SSS-FSAR

QUESTION 211.1

SUSQUEHANNA STEAM ELECTRIC STATION
UNITS 1 AND 2
FINAL SAFETY ANALYSIS REPORT

Figure 1

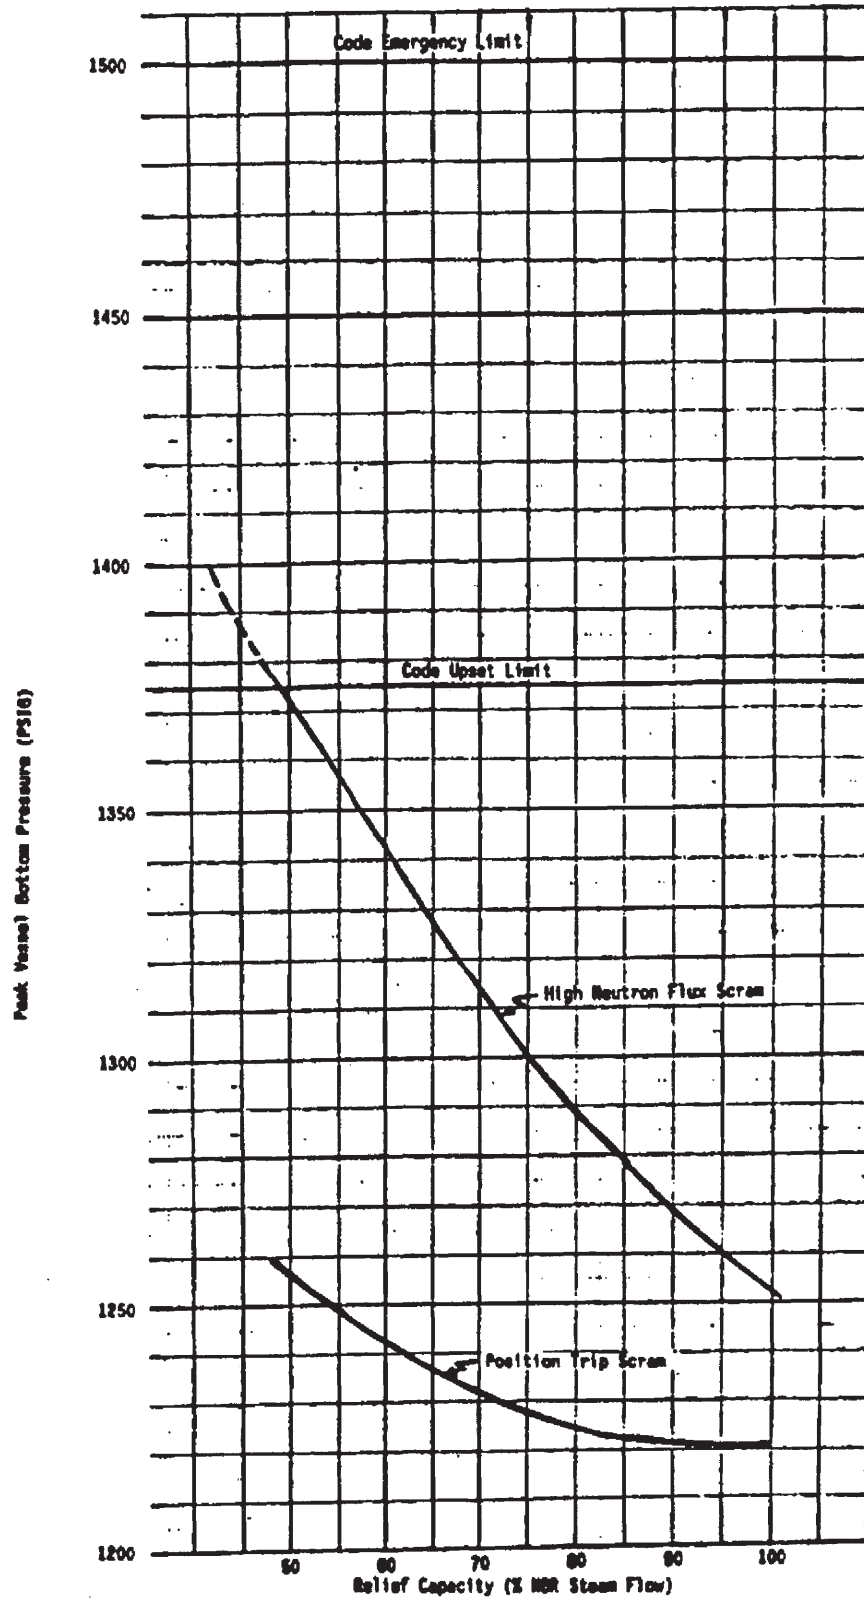
Acceptance Criterion II.2.b of SRP 5.2.2 states that, "All system and core parameters are at the values within the normal operating range, including uncertainties and technical specification limits, which would result in the highest transient pressure." Insufficient information is presented in the FSAR to determine that this acceptance criterion will be met. The applicant should confirm that the overpressure analysis will be based on an initial operating pressure (up to the Technical Specification limit) which will result in the most limiting peak pressure. The applicant should also confirm that the overpressure analysis will include the effects of the ATWS reactor recirculation pump trip on higher reactor pressure.

Acceptance Criterion II.2.c of SRP 5.2.2 states that, "The reactor scram is initiated either by the high pressure signal or by the second signal from the reactor protection system, whichever is later." The applicant has stated that the safety valve sizing analyses can take credit for the first indirect scram, which is the high neutron flux scram. The neutron flux scram occurs before the high pressure scram and results in a lower calculated peak pressure. The applicant should confirm that the safety valve sizing analyses will be based on the SRP acceptance criterion for reactor scram initiation.

Figure 1 characteristics the sensitivity of the peak vessel bottom pressure to safety/relief valve capacity for a typical high power density BWR for an MSIV closure with both direct and flux scram. Although a specific plant sensitivity to valve capacity may vary from that shown in Figure 1 the general trends shown in the figure are considered typical for all BWR's. The conditions assumed in the analysis of the information depicted in Figure 1 are given in Table 1. The results in Figure 1 clearly show the peak vessel pressures are below the ASME upset limit for the case of trip scram over a large range of safety/relief capacity. Similarly the peak pressures are also considerably below the ASME "emergency" and "faulted" limits for the case of flux scram.

FSAR FIGURE 211.19-1

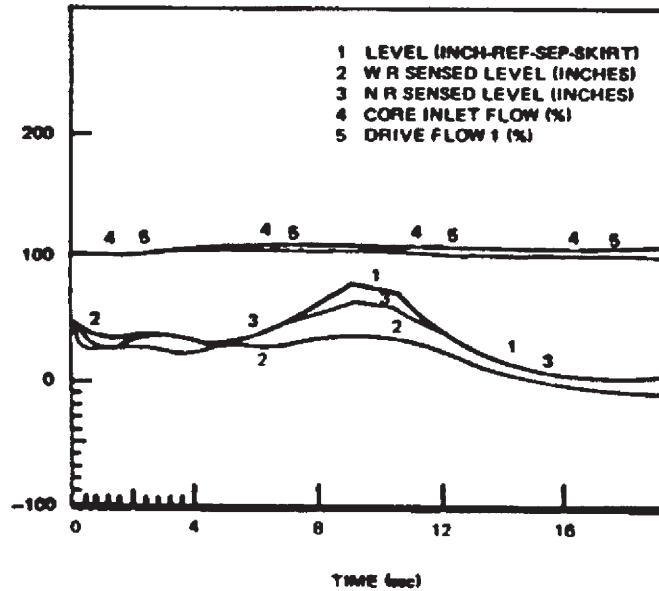
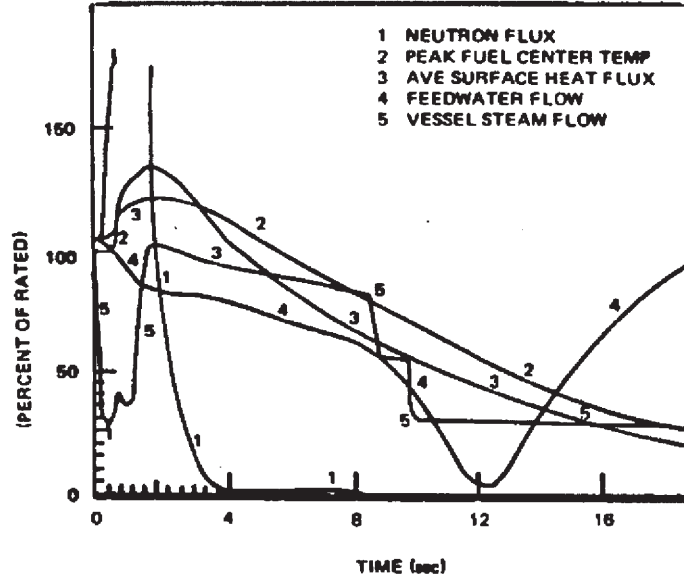
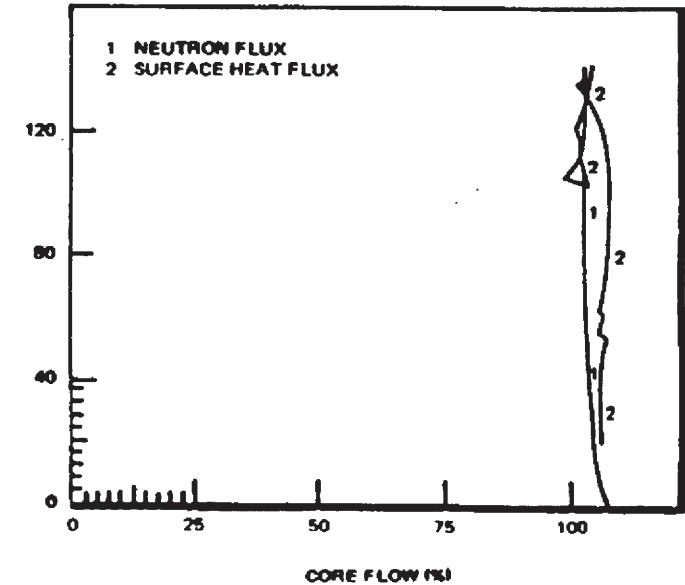
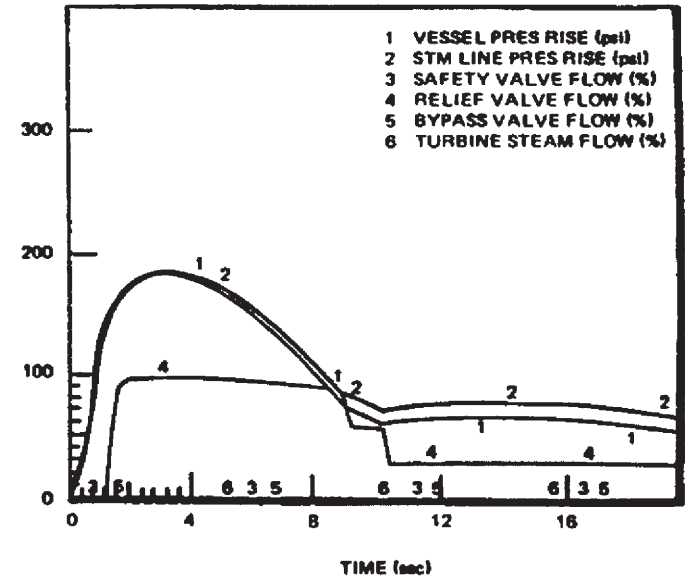
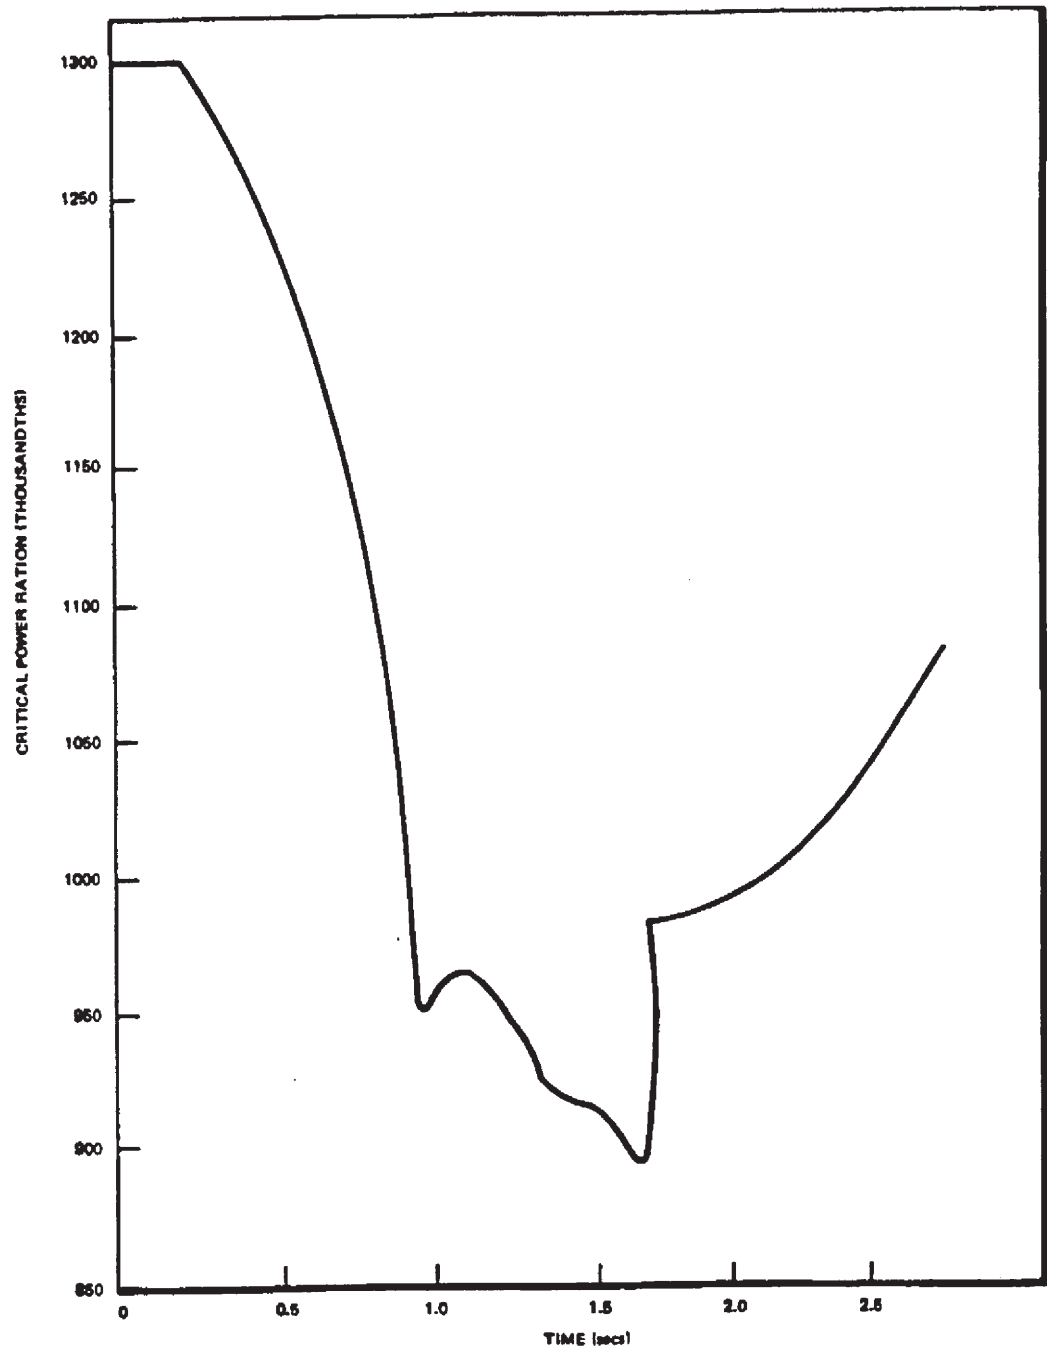
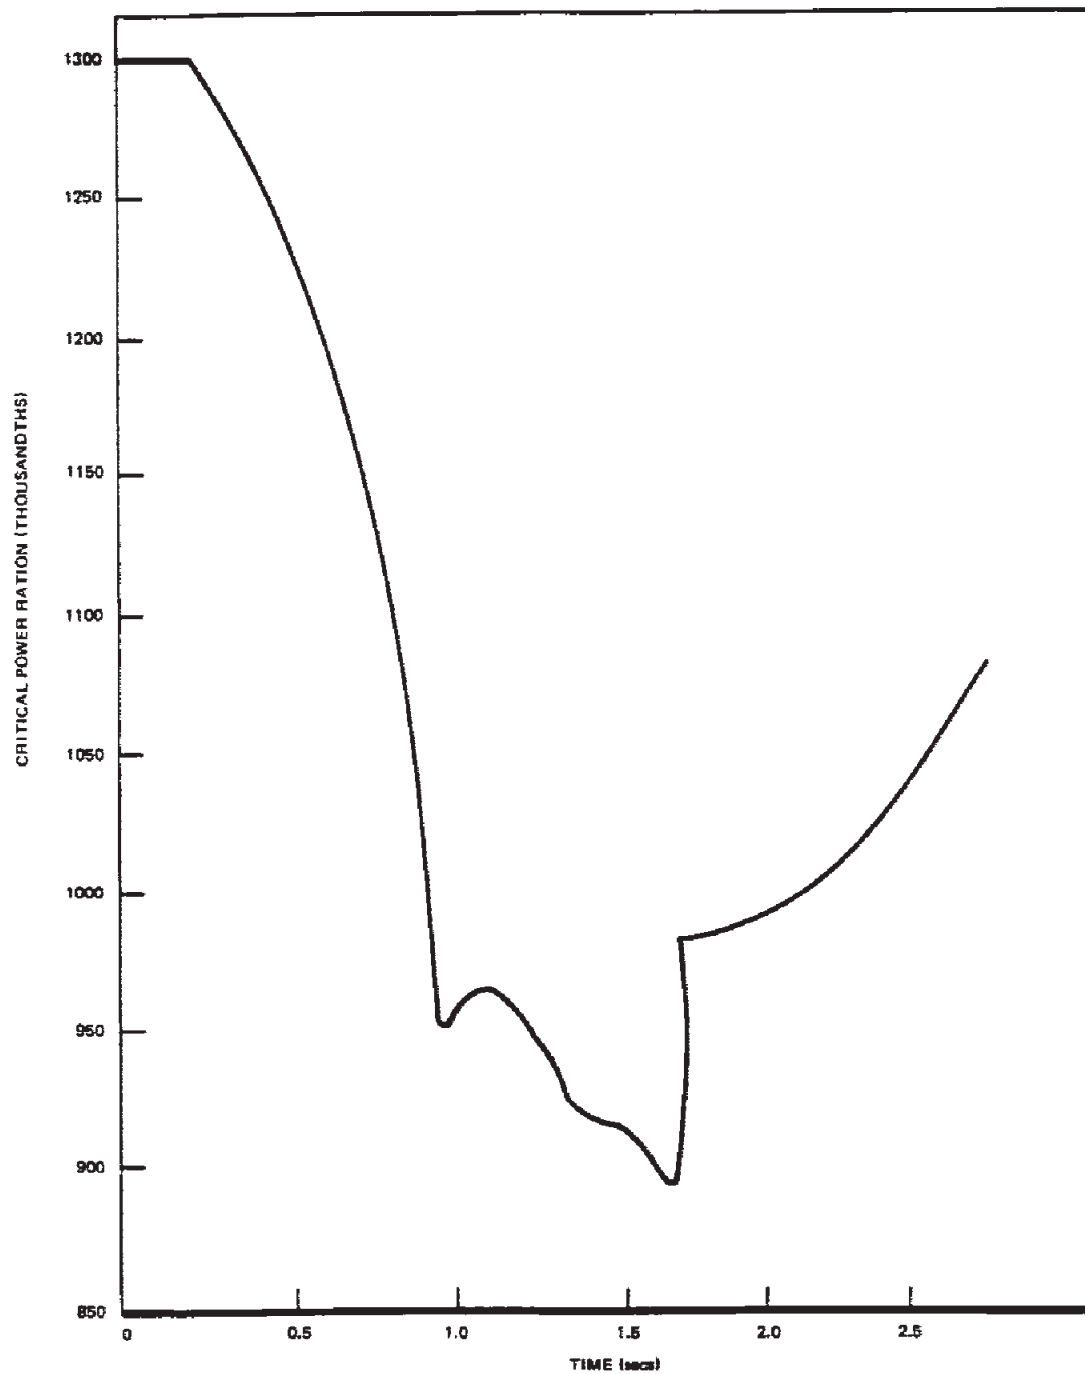
Per your response to Q211.19 regarding the analyses for generator load rejection and turbine trip transient, explain your statement that "... a loss of offsite power would improve the results of the above transient since the only additional effect would be a slow coastdown (in comparison to the RPT function) of the recirculation pumps," particularly since the RPT was intended to improve thermal margin.

A study was performed for Hatch 2 plant (BWR/4) analyzing the generator load rejection transient with concurrent failures of direct scram, RPT function, and bypass function. The results are represented in the attached Table 211.19-1 and Figures 211.19-1 and 211.19-2. Combining the results of the table of peak clad temperatures with the conclusions reached in the Letter Report "Transient Reclassification"¹, it was concluded that there will be no calculated fuel failures. This is based on experimental evidence and calculational studies given in the above document for conditions similar to those used in Hatch 2 analysis. The conclusions of the Hatch 2 study which considered single failures of safety-grade components are also applicable to Susquehanna.
